**TOWN OF PRESCOTT VALLEY MEMORANDUM**  
**UTILITIES DEPARTMENT**

**1st Review**

Re: Brakes Plus – Final Development Plan

Permit Number: FDP24-008

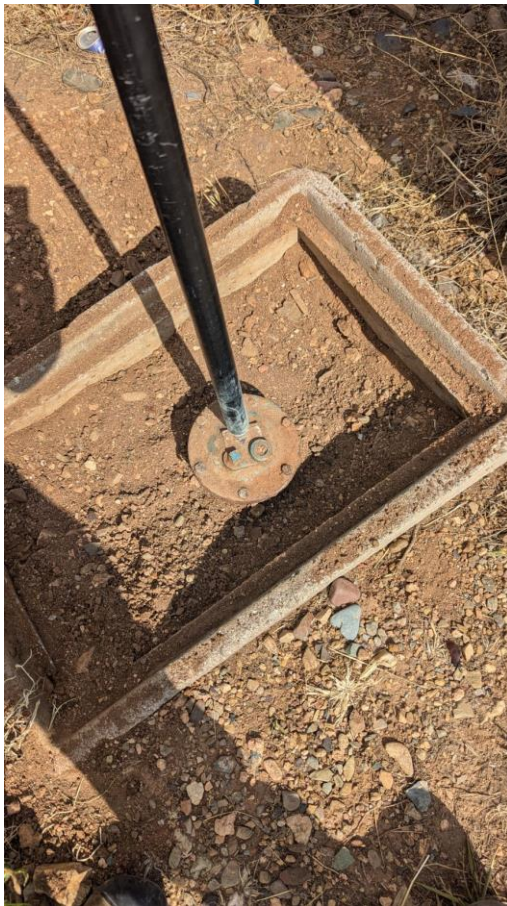
- Records indicate that the southwest water line is teed, valved, then flanged with an air release valve and doesn't extend past that (see attached As-Builts). Was something found that shows otherwise so we can correct our records?
  - **Only items on the surface are the mainline valve and water meter box & setter (no meter). Further south, there is a meter box that is flanged off, see picture**
